REVISED RESPONSE TO REQUEST FOR ADDITIONAL INFORMATION

APR1400 Design Certification

Docket No. 52-046

RAI No.: 235-8275
SRP Section: 12.03-12.04 – Radiation Protection Design Features
Application Section: 12.3-12.4
Date of RAI Issue: 10/07/2015

Figure 1. Locations of Skimmer Suctions of Refueling Pool Water

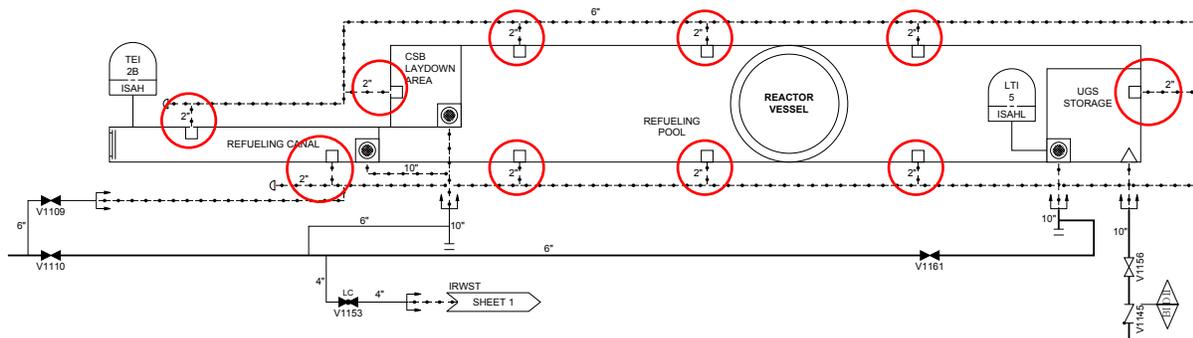
10 CFR 20.1101(b) requires in part that licensees use, to the extent practical, procedures and engineering controls based upon sound radiation protection principles to achieve occupational doses ALARA. KHNP indicates that there is no intent to use a temporary filtration system in the refueling pool during refueling operations and when cutting in-core instrumentation. Similar temporary filtration systems are used widely in U.S. plants. A filtration system lowers contamination levels in the refueling pool water, reduces the amount of plate-out of radioactive particles on the refueling pool walls and floor when emptying the refueling pool, and reduces airborne radioactivity levels in containment due to lower contamination levels.

It is the staff's position that in accordance with ALARA, the design should support the use of such a system. If the design does not include a sufficient power supply inside containment to

support the use of a filtration system, the COL applicant may not be able to use such a system or it may result in additional operational constraints and potentially dose to provide power to such a system from elsewhere. It would be up to a COL applicant how they would use a temporary filtration system and where spent filters would be stored, which would be covered as part of the plants radiation protection and ALARA program, but the design should support its use. Therefore, the design should include information indicating that an appropriate power supply and connection would be available to support the use of a portable filtration system in containment and that there is adequate space in the refueling pool for its use (the applicant should ensure that the power supply is sufficient to support the use of portable filtration systems).

From the above question, KHNP interprets that the staff is concerned about the absence of the provision to purify the refueling pool. As discussed and illustrated in Figure 1 above, and summarized in DCD Section 9.1.3, the SFPCCS is designed to purify the water of the SFP, IRWST, fuel transfer canal and the refueling pool during the refueling operation as well as SFP cooling. Therefore, it can reduce the concentration level of radioactivity in the refueling pool, and thus maintain the lower level during refueling operation. This justifies that the temporary filtration system to clean up the refueling pool is not required.
